**SUBJECT: Drainage Channel PCB Assessment Work Plan
Kuhlman Electric Corporation
Crystal Springs, Mississippi**

**COMMENTS ON THE REMEDIATION WORK PLAN FOR KUHLMAN
ELECTRIC PLANT SITE, KUHLMAN ELECTRIC CORPORATION, CRYSTAL
SPRINGS, MISSISSIPPI, MAY 2001**

Re: Revised Maps for Site Remediation Reports
Medical Center and Dabney-Smith Properties
Crystal Springs, Mississippi

SUBJECT: BorgWarner Inc.'s Response to EPA's Comments
Remediation Work Plan for
Kuhlman Electric Corporation Plant Site
Crystal Springs, Mississippi

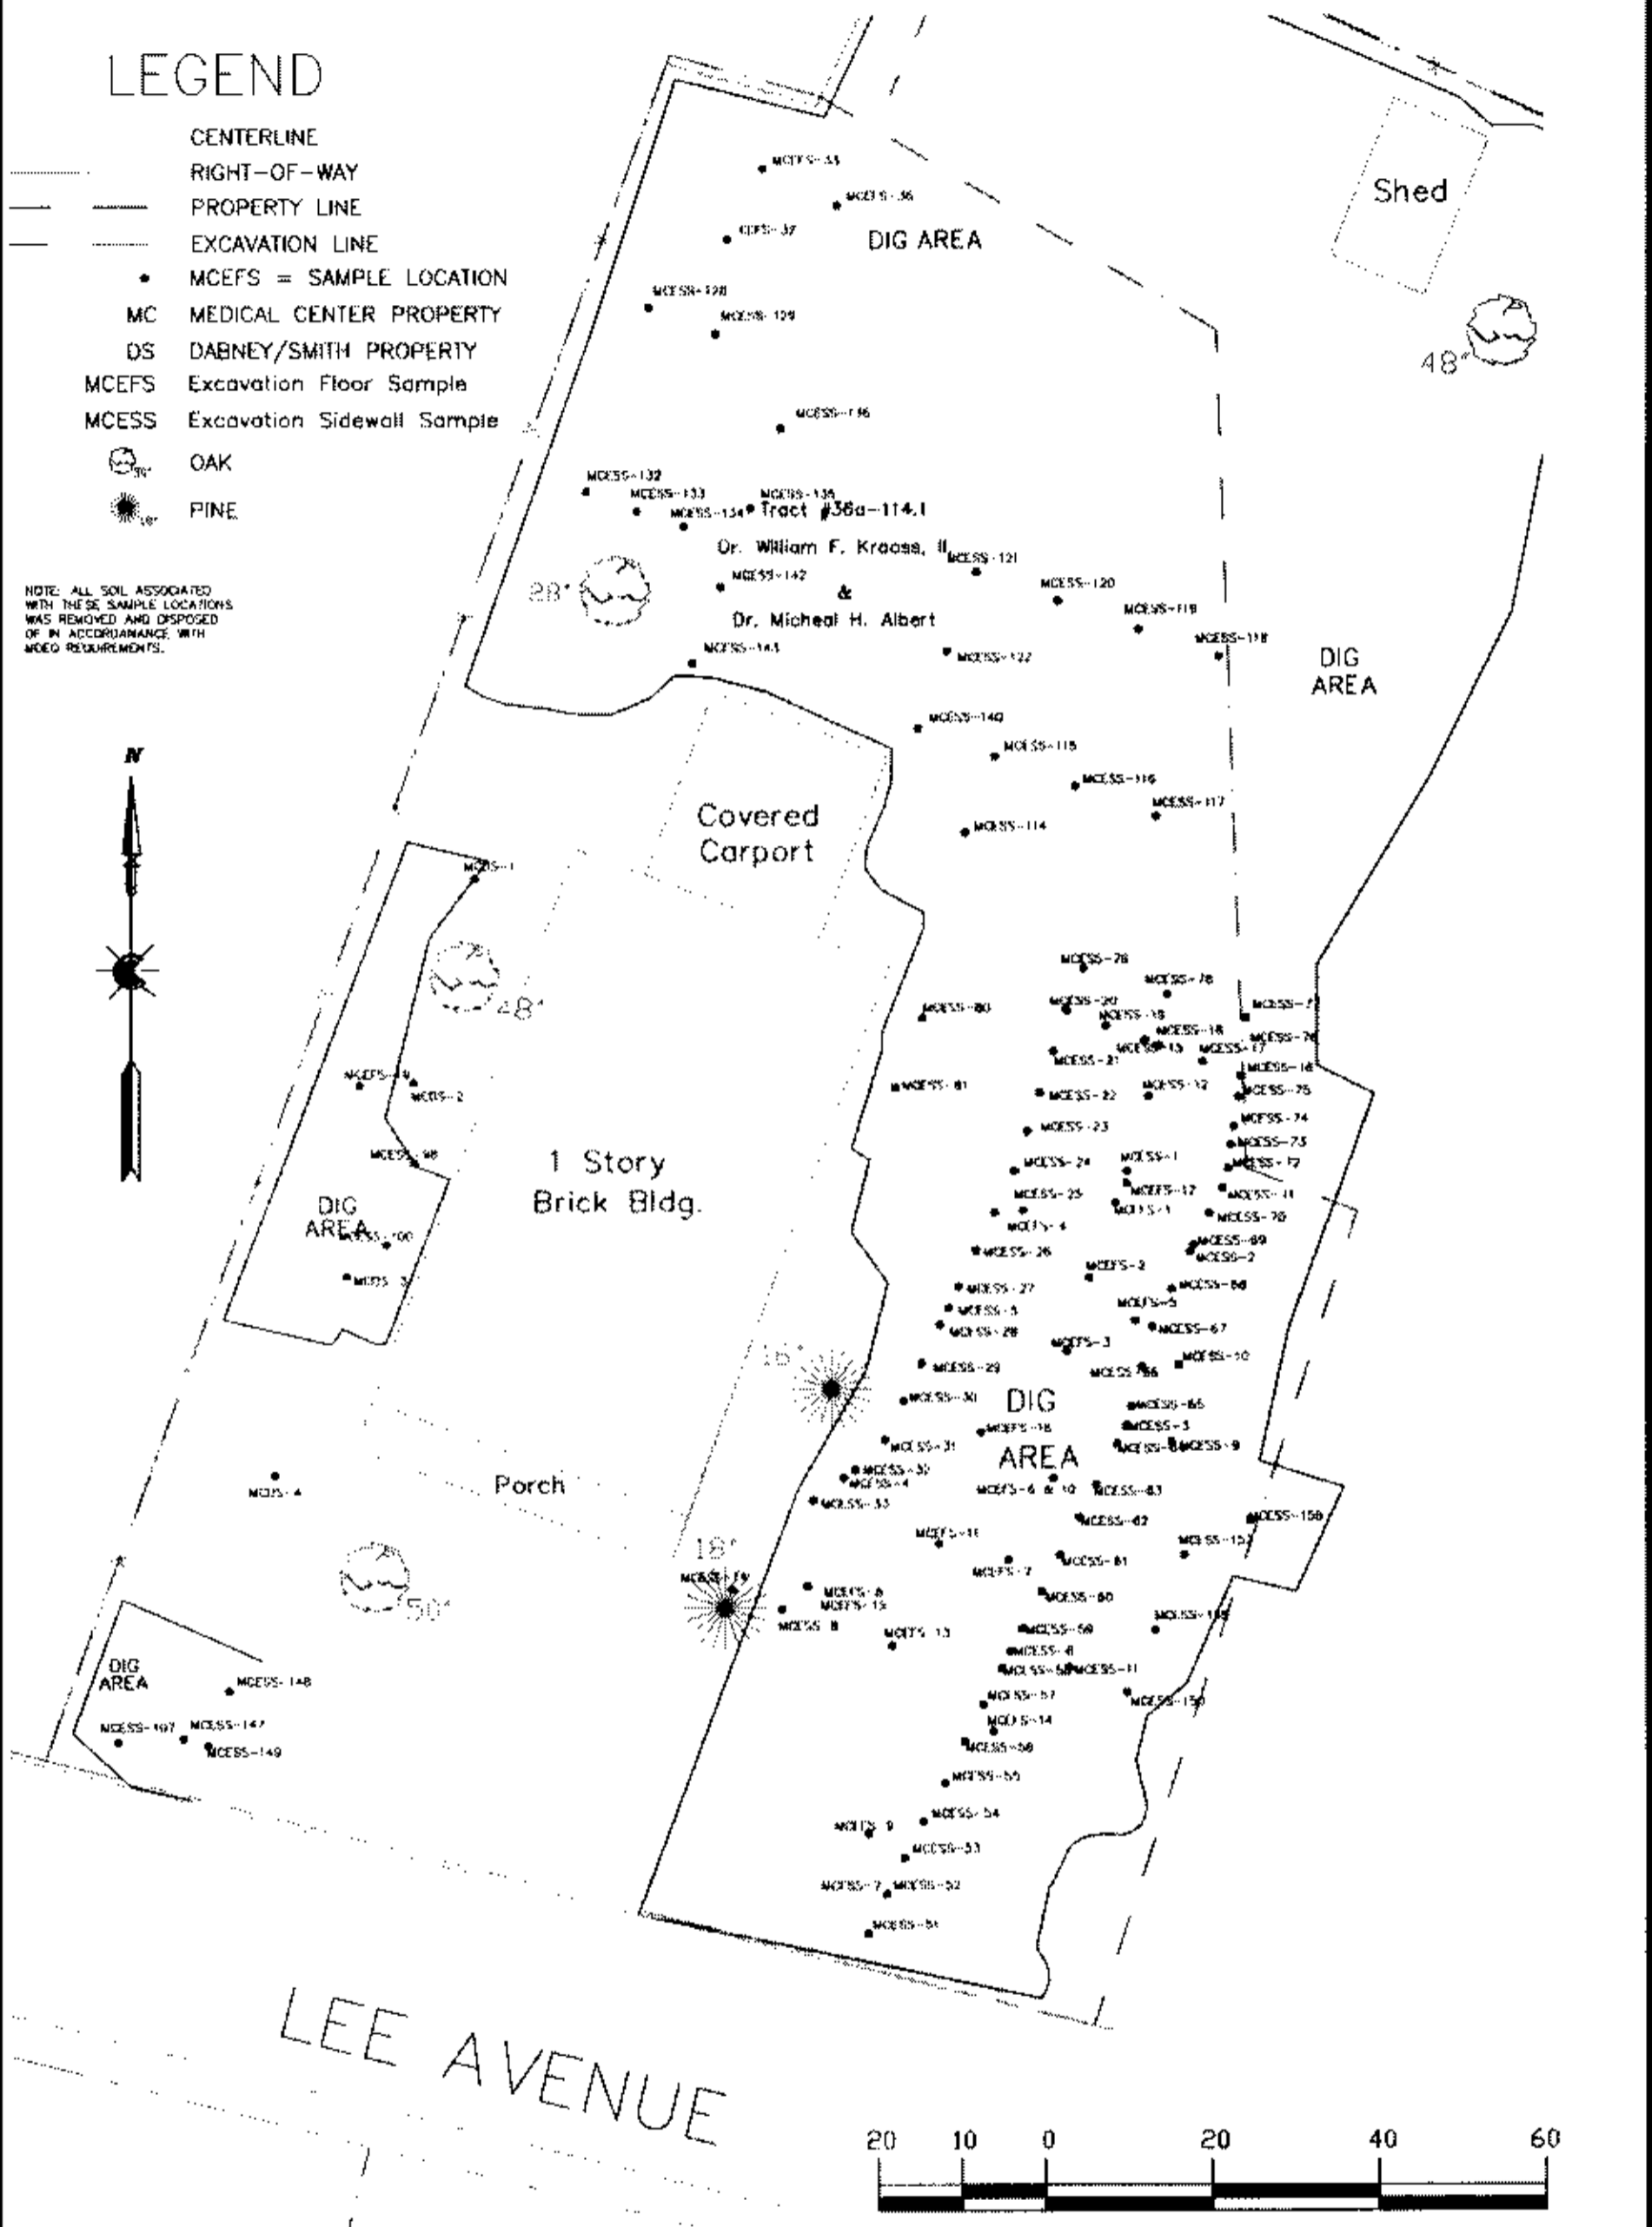
2. The following sampling locations were on both Figures 2 (revised) and Figure 3, but in different locations: MCESS-52, MCESS-53, MCESS-54.

3. On Figure 2, MCEFS-73 is on map twice-once by covered carport and once on the Dabney/Smith-medical clinic property line; only have data for one sample.

SCALE
 1" = 20'
 FIGURE
 3

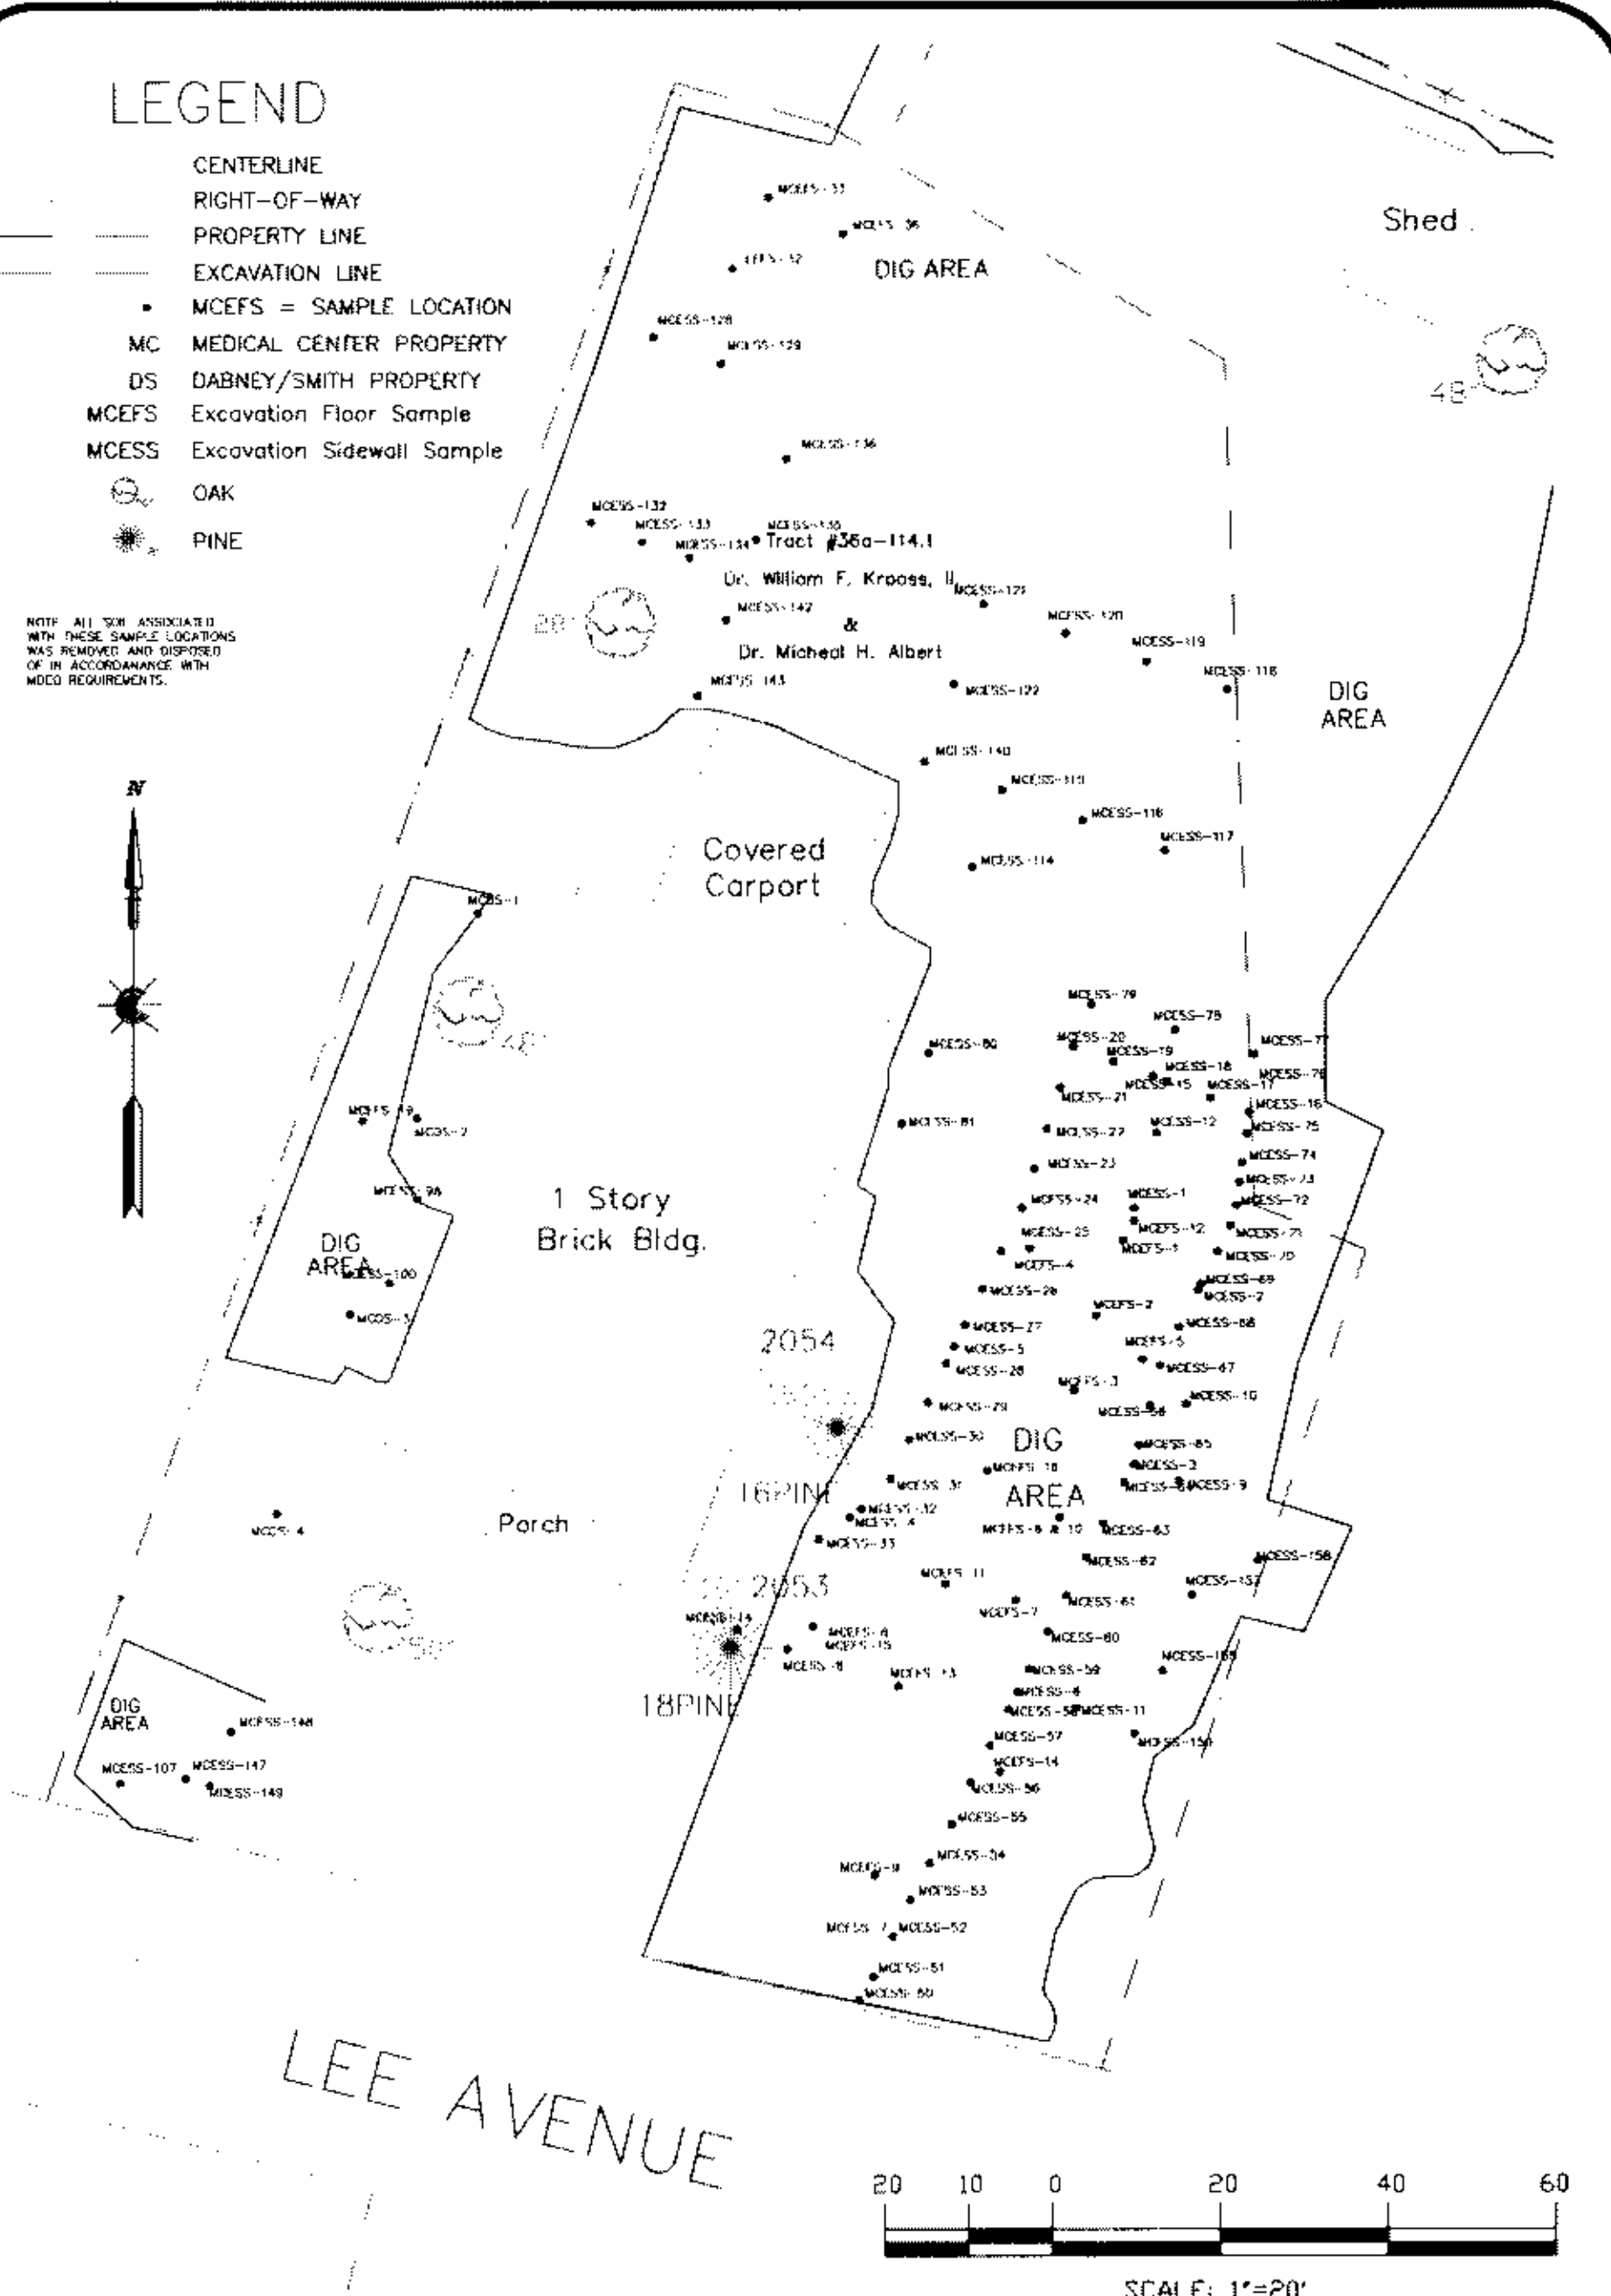
1. On Figure 3, the following sampling locations are mislabeled: MCESS-8 given as KESS-8, MCESS-117 given as E117, MCEFS-5 given as MCEFC-5, MCDS-3 given as MCD5-3, MCDS-4 given as MCD5-4. MCESS-1 is on map twice-once by 18" pine and once in driveway; only have data for one sample. There was no data submitted for the following sampling locations: MCESS-47, MCESS-48, MCESS-49, MCESS-50.

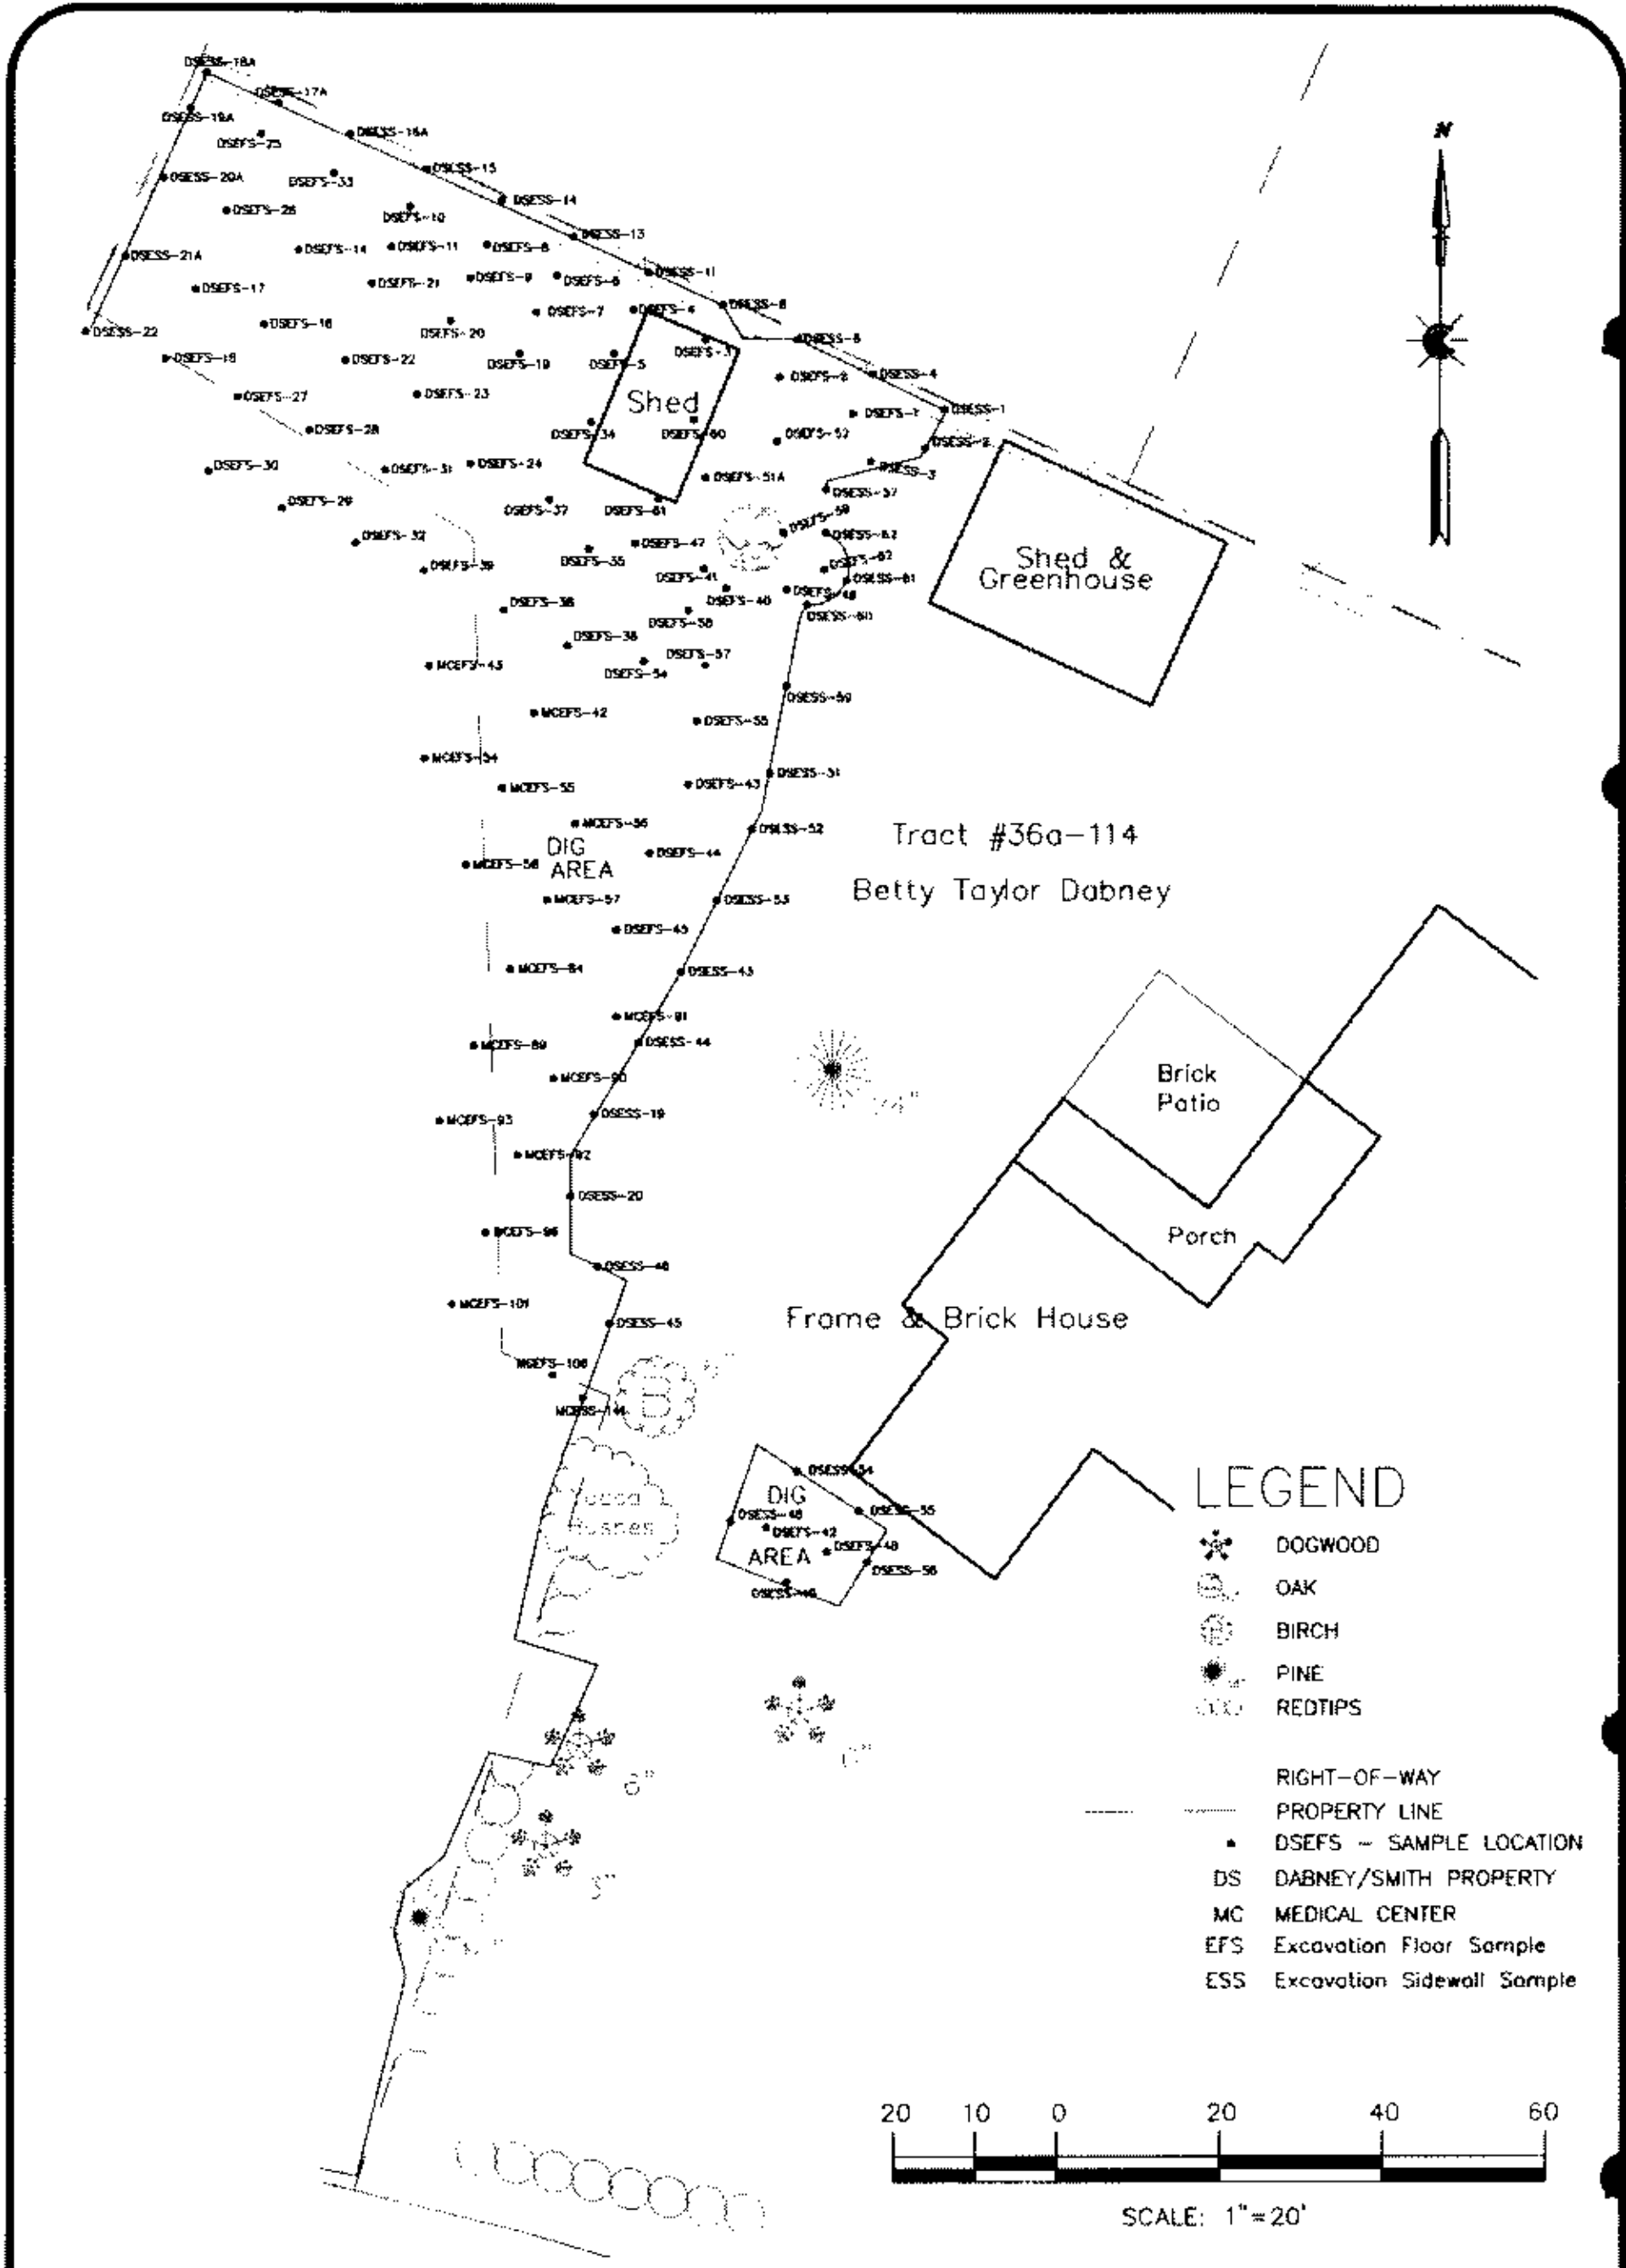
2. On Figure 2 (revised), DSEFS-39 given as EFS-39.
